NABI Service Bulletin No: SB-13-02-02

Subject: Disabling Front-Facing Flip-Up Seats

Applicability: NABI buses where the first row of forward-facing, flip-up seats directly behind the wheelchair areas have no barriers in front of them. This bulletin does not relate to buses where there is a barrier in front of the first row of front-facing seats.

Date Issued: December 13, 2013

Figure 1: Typical Forward Facing Flip Up Seat Location

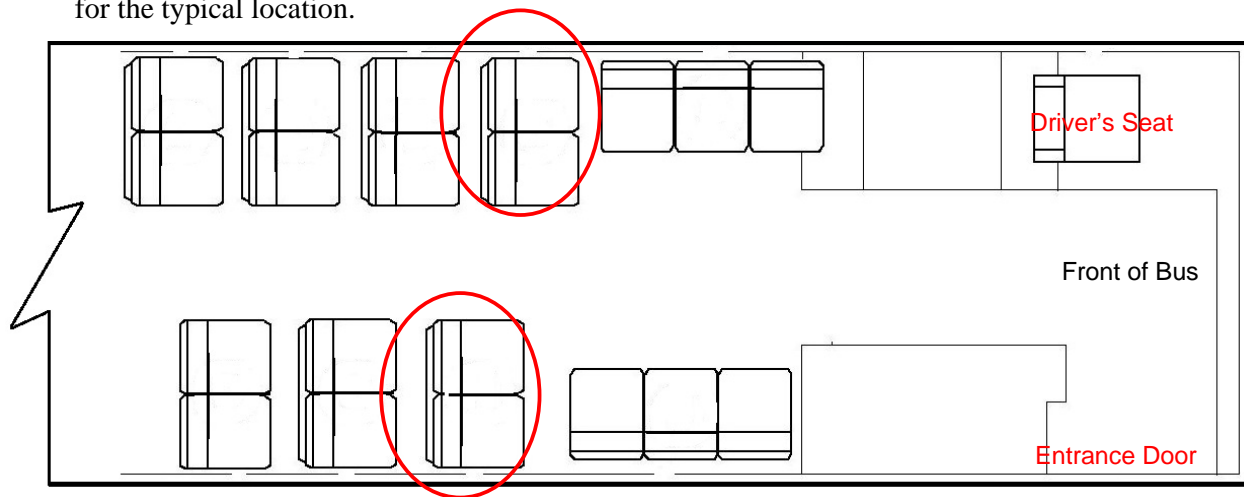
1. Locate the forward facing flip up seats that do not have a “barrier” in front of them. See Figure 1 for the typical location.

Figure 2: Typical Locking Rod in Extended Position

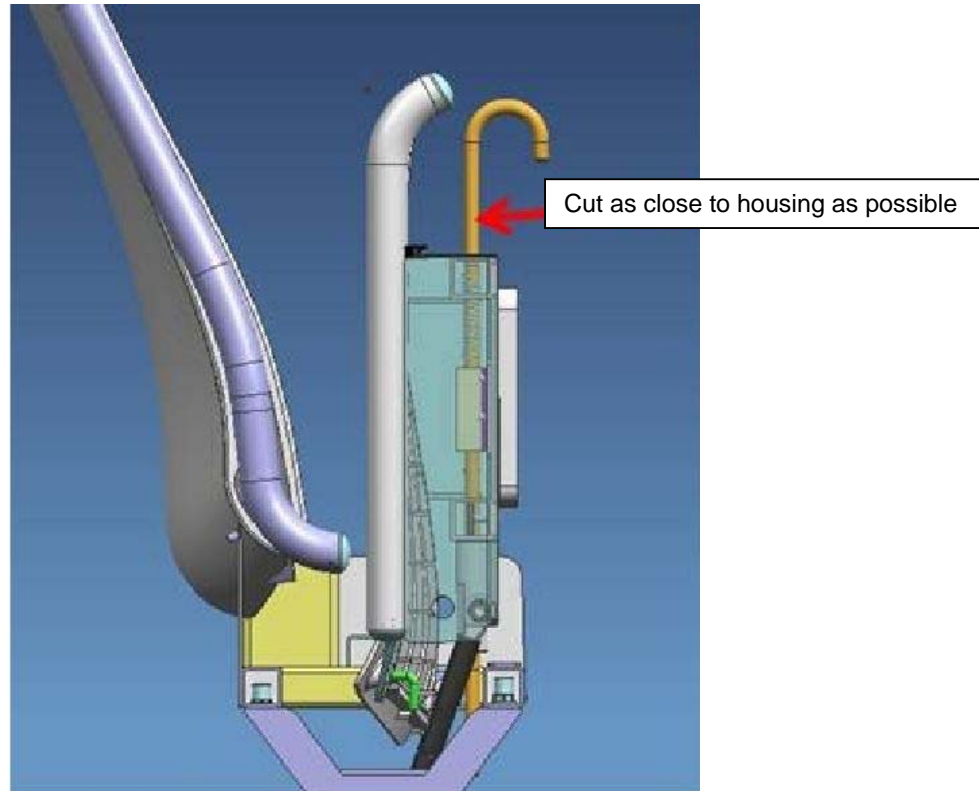
2. Flip the seats into the upright position.
3. Extend the locking rod and secure it in the extended position. See Figure 2.

4. Cut the pull handle of the locking rod off as close to the housing as possible. See Figure 2.

Figure 3: Locking Rod Handle Removed

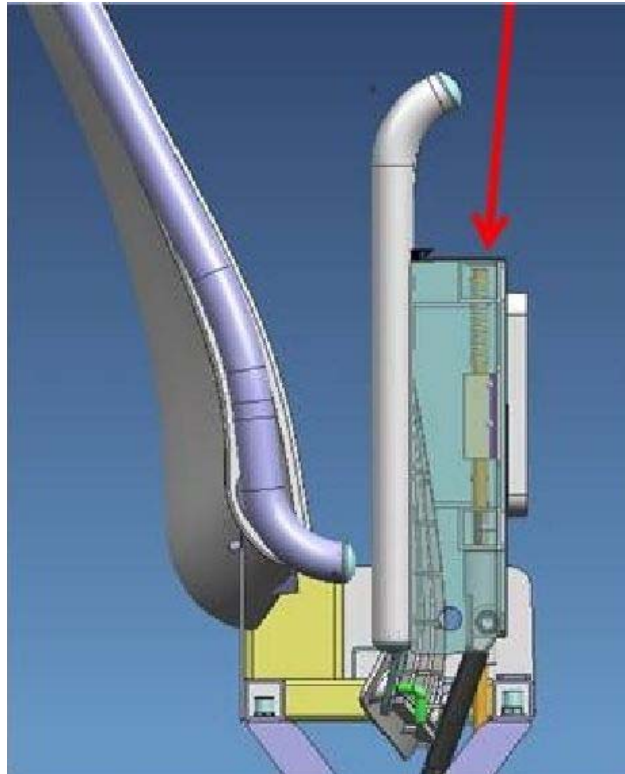
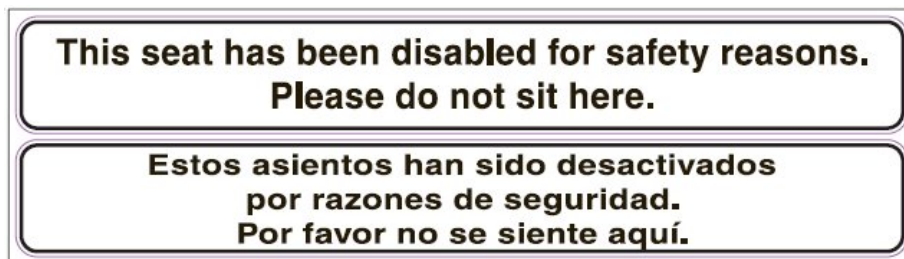
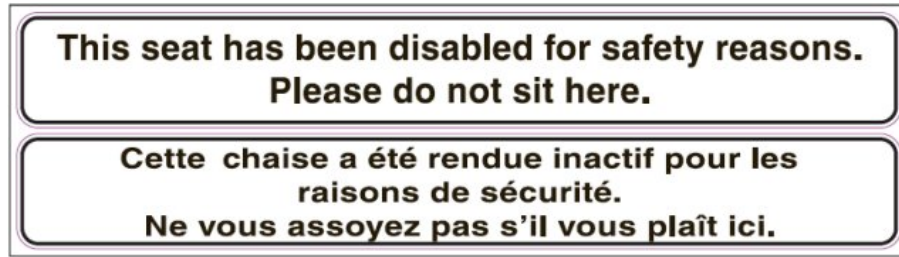
5. Once the locking rod pull handle has been removed, unsecure the locking rod and let it recede into the seat bottom. See Figure 3.

Locking rod cut and receded into housing
